Agenda Item # 11

ZON-UDC-003666-2026

Proposed Zoning:

APPLICATION NUMBER <u> 11 </u> DATE <u> April 16, 2026 </u>	
APPLICANT <u> Christopher J. Hughes </u>	
REQUEST <u> Rezoning from R-1 to B-3 </u>

SITE PLAN

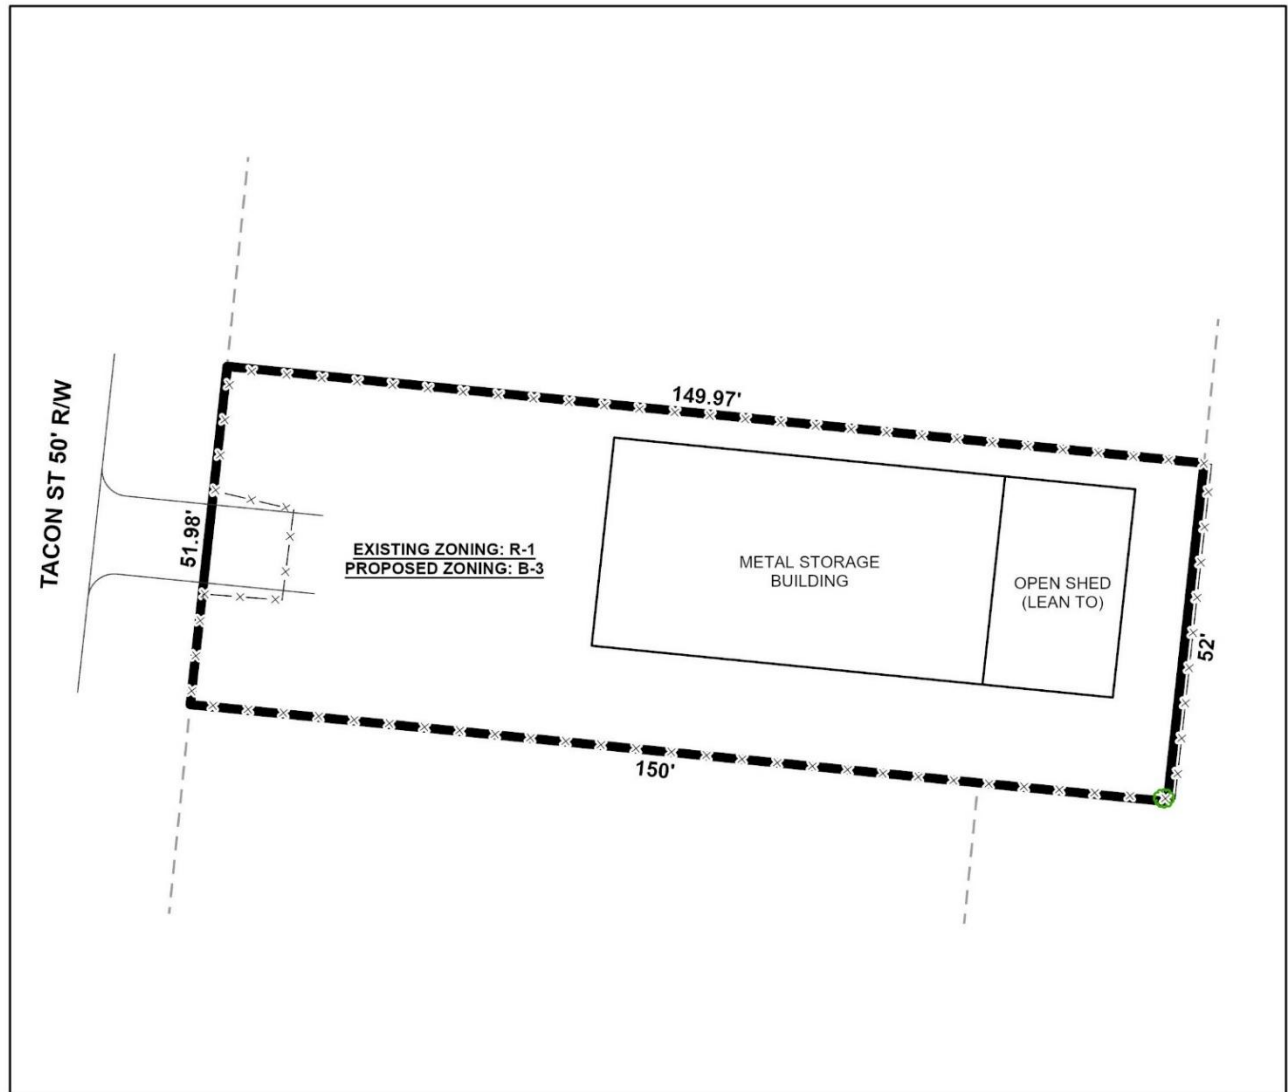
The submitted site plan depicts an approximately 1,800-square-foot metal storage building with an attached 600-square-foot lean-to at the rear. It also shows compliant residential buffers along all sides adjoining R-1 properties. A note indicates that a compliant landscape plan will be submitted at the time of permitting and that garbage service will be provided via curbside pickup.

However, the site plan does not include any parking spaces, depicts a substandard driveway, and shows the proposed structure located too close to the residential property to the north. If approved, the development must comply with all applicable building and site design standards set forth in Article 3 of the UDC.
